ECE1200 Silicon Errata and Data Sheet Clarification

TABLE 1: DEVICE IDENTIFICATION

FIGURE 1: INITIALIZATION SEQUENCES FOR REGISTER ACCESS

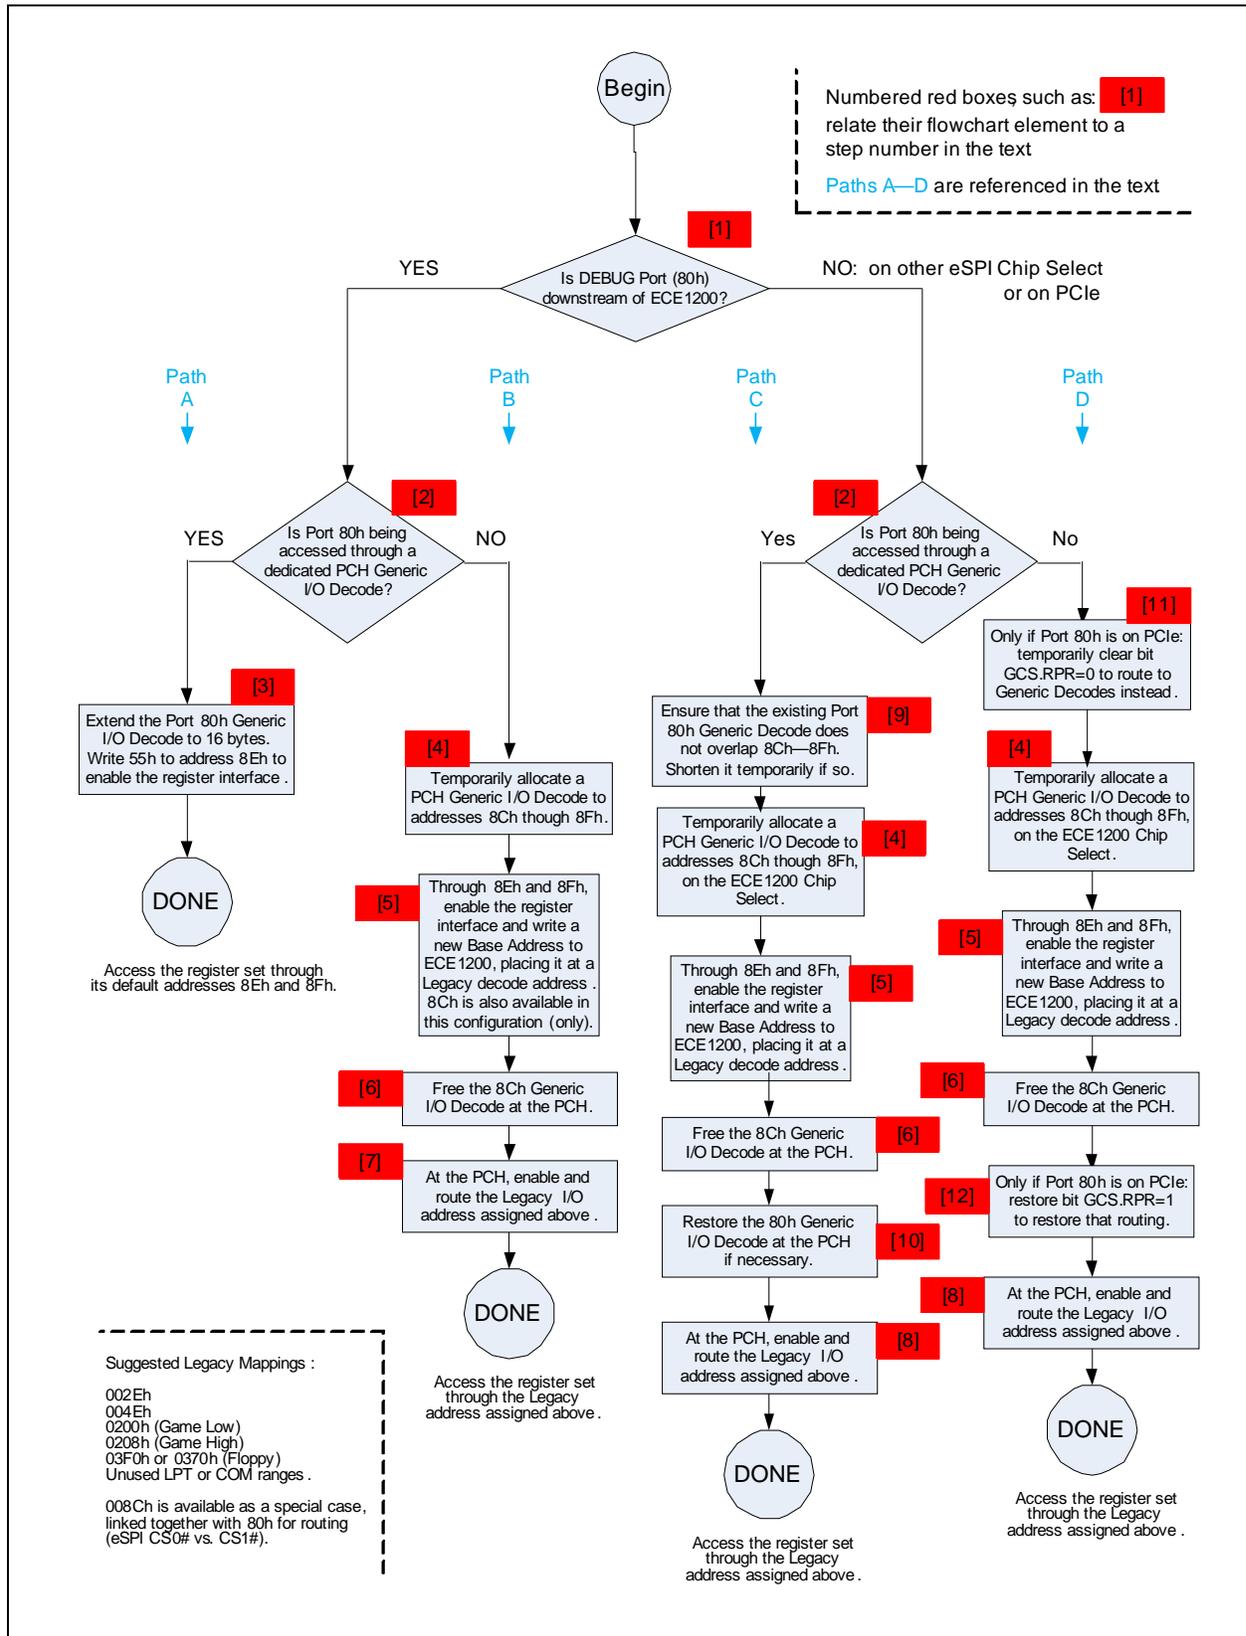
It has been discovered that an initial I/O Base Address of 008Eh for this device makes the DATA register (at 8Fh) not easily accessible through the Host Chipset in some system configurations. Starting with Functional Revision B, this address is changed to 008Ch, placing INDEX at 8Ch and DATA at 8Dh. The data sheet release is now edited to document the much simpler initialization requirements resulting from it. The old initialization requirements are given in the Work Around section below.

Changing the HW default Base Address to 8Ch makes both the INDEX and DATA I/O locations of the device accessible in place, and usually by HW default in the Host Chipset. Moving the Base Address, if necessary, is also greatly simplified, and need not involve anything but Legacy decode ranges in the Chipset.

Re-assignment of the Base Address was mandatory in many system configurations, and the process of accomplishing this was fairly complex, as shown below.

Figure 1 illustrates the sequences used in order to map the register set as desired. These are explained in more detail in the Step list below.

Referring to Figure 1, the first two decisions, Step [1] and Step [2], separate the initialization process into one of four “Paths”, Path A through Path D. These are based on the intended system mapping of the Port 80h (“Debug Port” or “RPR”) I/O region.

According to the above decisions, one of the Paths in Figure 1 is taken, and this determines which of the Steps below are taken, and in which order.
